# **AGENDA**

Planning Committee Meeting to be held at Darebin Civic Centre, 350 High Street Preston on Monday, 13 May 2019 at 6.00pm.

5.1 APPLICATION FOR PLANNING PERMIT D/648/2018

345 Bell Street Preston

#### Southern Interface

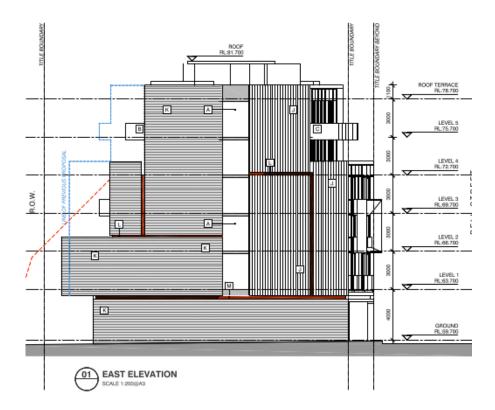
Member Daicic made the following comments with regard to the southern interface:

Whilst I consider that it is possible to have a multi-storey building on the review site, it needs to be moderated significantly to the rear to manage the visual bulk impacts in particular (in addition to overshadowing and overlooking impacts). I find that the number of levels when viewed from the rear and the building profile is simply too robust at the residential interface. It is unsympathetic and not a sensitive response to its context. The building has not been sufficiently recessed to an acceptable level, particularly at the upper levels to moderate the building's visual presentation

I consider that an appropriate increase to the rear setbacks of the proposal will assist in reducing the perception of visual bulk despite the evidence of Mr Iles who has assumed that the rear yards of these properties are likely to be developed to a height of 2 storeys or 9 metres.

A more sensitive design approach that is tempered at the sensitive interface to the rear might well produce an outcome in favour of net community benefit given the strategic planning policy imperative for some form of multi-level development on this site.

#### Reduced daylight to adjoining northern and southern property

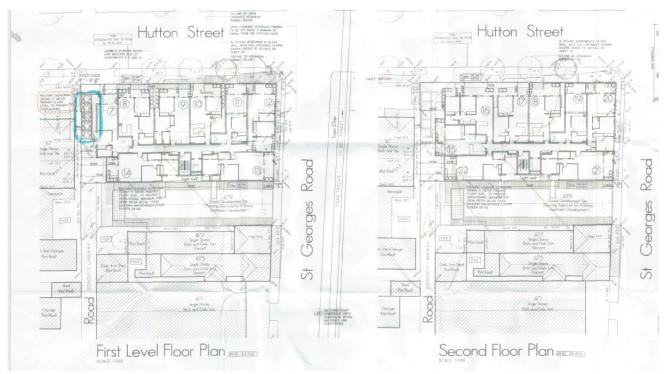
The land to the south is a single-storey building and the land is in the Commercial 1 Zone. Council has assigned this property, under the Australian Valuation Property Classification Code, a shop use category. The shop windows are oriented to St Georges with some windows to the rear of the building oriented to the side setback. The development proposes boundary to boundary construction with two light courts to the south boundary. Whilst the proposed walls on the southern boundary would affect daylight to the adjoining windows, the windows are not associated with a residential use and are not afforded the same level of amenity protection as a dwelling. This notwithstanding, the setback of the adjoining windows from common boundary vary between 0.99-1.062 metres and this will maintain an acceptable light court with an average width of 1 metre and an area of 3 square metres open to the sky. In some areas this light court is increased by the simultaneous light courts proposed by the development.

Diagram E: South Elevation showing 45 degree rear building envelope and maximum 17 metre building height.

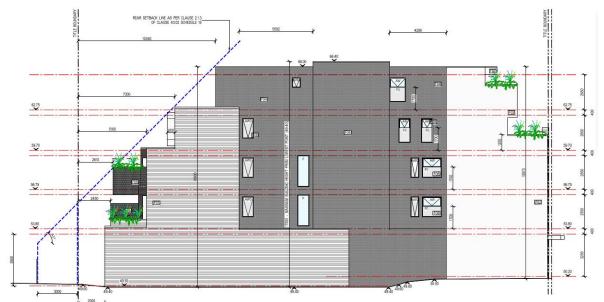
The subject site is within the Ballantyne Street to Miller Street Precinct on Map 6 of Schedule 16 to the DDO. The following design requirements apply to the site under the DDO:

- A height limit of five (5) storeys (a maximum height of 17 metres)
- Rear building envelope of 45 degrees, including the Right of Way
- Active frontages to St Georges Road.

The development provides a five (5) storey building and is set back from the rear boundary (including the 3.05 metre wide laneway) in accordance with the 45 degree building envelope, as seen in the Diagram E above). The majority of the front façade at Ground Floor is comprised of glazing to present an active frontage to St Georges Road.
